# UNITED STATES PATENT AND TRADEMARK OFFICE

10/525,703

<b>Office Action Summary</b>	<b>Application No.</b> 10/525,703	<b>Applicant(s)</b> RUOTOISTENMAKI, HEIKKI	
	<b>Examiner</b> MICHAEL C. STOUT	<b>Art Unit</b> 3736

## **DETAILED ACTION**

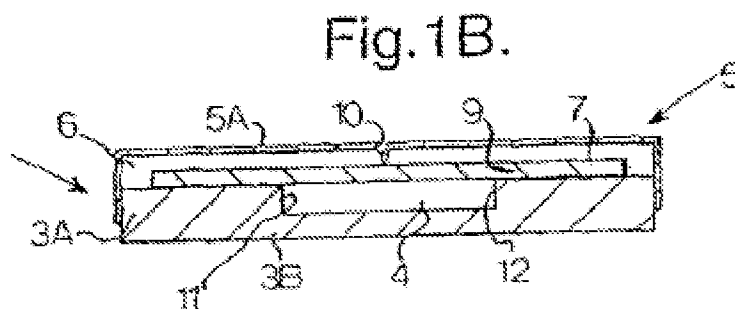
Freakes teaches a force or pressure sensor, comprising a substantially rigid, mechanical-load resistant frame (frame 3A), a flexible diaphragm secured over its peripheral rim to the frame (substrate 7), and a piezoelectric sensor diaphragm applied to the surface of the flexible diaphragm (SAWs device Y is laid down on the substrate, see Page 5, Paragraph 2) wherein the sensor diaphragm loading element comprises a substantially rigid cover capable of carrying mechanical loading (lid 5 which functions as a diaphragm and transmits a load via member 10 to substrate 7) wherein the cover includes a protrusion or shoulder (projection 10), bearing against a middle section of the flexible diaphragm and thus (see Figure 1B),

by deflection, prestressing the flexible diaphragm and the piezoelectric sensor diaphragm attached thereto (a recess 10 is formed in the lid and presses on the central region of the substrate, see Abstract and Page 5, Paragraph 4), and wherein the frame

and the cover define therebetween a closed housing chamber (see Figure above), the flexible diaphragm and the piezoelectric sensor diaphragm being located there inside (see Figure 1B). Freakes in view of Reuter teaches the device wherein the frame, cover and the flexible diaphragm are rotationally symmetrical relative to the cover protrusion or shoulder (Freakes teaches a device wherein the frame, cover and flexible diaphragm are symmetrical about the cover protrusion, see Figure 1A). Freakes fails to teach the SAW diaphragm comprised of a piezoceramic material. Bagdassarian teaches a SAW device comprised of piezoceramic substrate, see Figure 1 and Column 4, Lines 35-45). Both Freakes and Bagdassarian teach SAW devices. Thus it would have been obvious to a person of ordinary skill in the art to modify the device taught by Freakes to include piezoceramic material as taught by Bagdassarian in the SAW diaphragm in order to provide a material to ensure acoustic wave propagation. Freakes teaches a cover which is capable of having a +50kg load placed on it. Nevertheless, Reuter teaches a load cell having a cover capable of carrying a mechanical loading of more than 50 kg (the button in Figure 1E is preferred for load cells with more than 50kg ratings, see Column 5, Lines 23-31). Both Freakes and Reuter teaches load sensing devices. Therefore, it would have been obvious to a person having ordinary skill in the art at the time of the invention to modify the device taught by Freakes by making the cover capable of carrying mechanical loading of more than 50kg as taught by Reuter in order for the device to operate in environments requiring at least a 50kg load to be detected thereby increasing the usability of the sensor, see Column 5, Lines 23-31. Freakes fails to teach the device comprising a sensor-signal transmitting conductor is in

**FIG. 1**

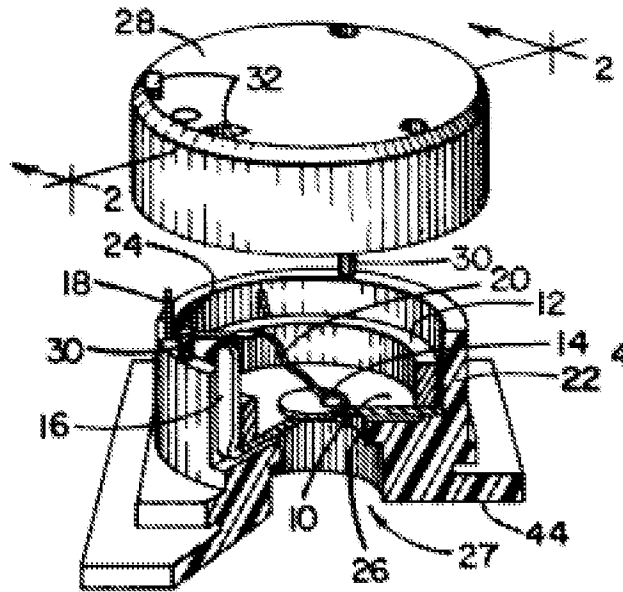
Regarding claim 3, Freakes teaches the device wherein the flexible diaphragm comprised of a substrate (7), having its peripheral rim secured between the edges of the frame and the cover (substrate may be secured to the base by means of an adhesive, see Freakes Page 5, Paragraph 3, Figure 1 shows the substrate is secured between the

edges of top of the frame and inside cover). Freakes fails to teach the device wherein the diaphragm is metal. Guscott teaches a transducer device comprising a metal diaphragm. Both Freakes/Reuter and Guscott teach transducer devices. Thus, it would have been obvious to a person having ordinary skill in the art at the time of the invention to modify the device taught by Freakes/Reuter to include a metal diaphragm as taught by Guscott in order to employ a metal diaphragm which has improved immunity to environmental and aging conditions, see Guscott Column 2, Line 60 through Column 3, Line 8. Regarding claim 7 Freakes teaches the device wherein frame and cover are made of bodies. Freakes fails to teach the device wherein the frame and cover comprise elements in the shape of bodies of revolution. Guscott teaches a transducer device wherein the cover (28) and frame (22) and diaphragm (10) are rotationally symmetrical wherein the frame and cover comprise elements in the shape of bodies of revolution.

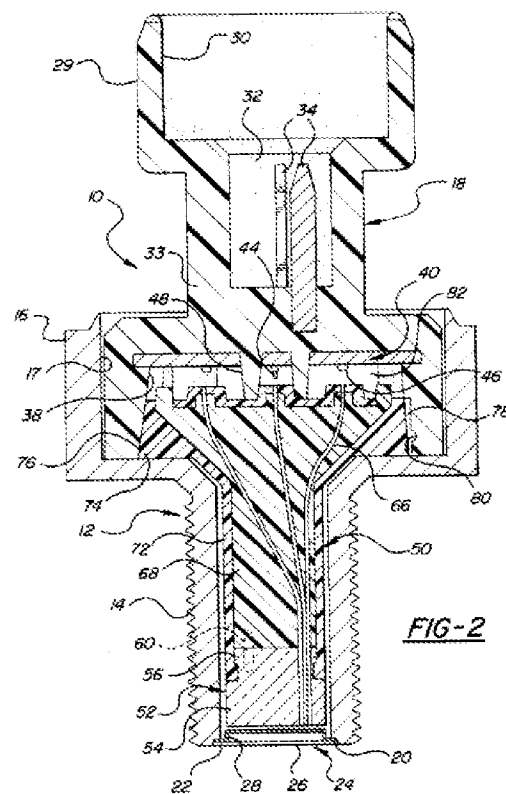
Regarding claim 9, Freakes/Kusakabe teaches the device wherein comprising an amplifier. Freakes/Kusakabe fails to teach the device wherein the amplifier has its input impedance matched to provide a desired settling time of the amplifier's output, during which the amplifier has its output set substantially to zero, while the loading applied to the cover respectively remains essentially unchanged. Zhang teaches an amplifier for a sensor wherein the amplifier has input impedances matched (the settling time (the response time for a amplifier to return to its zero state after a step response input) is a function of capacitances associated with the amplifier with alter the impedances of the respective input signals, see Column 4, Lines 6-19), to provide a desired settling time. Both Freakes/Kusakabe and Zhang teach amplifiers for sensor device. Therefore, it would have been obvious to a person having ordinary skill in the art at the time of the invention to modify the device taught by Freakes/Kusakabe to include a matched impedance as taught by Zhang in order to provide a settling time sufficient enough to record rapid changes in the sensor output.
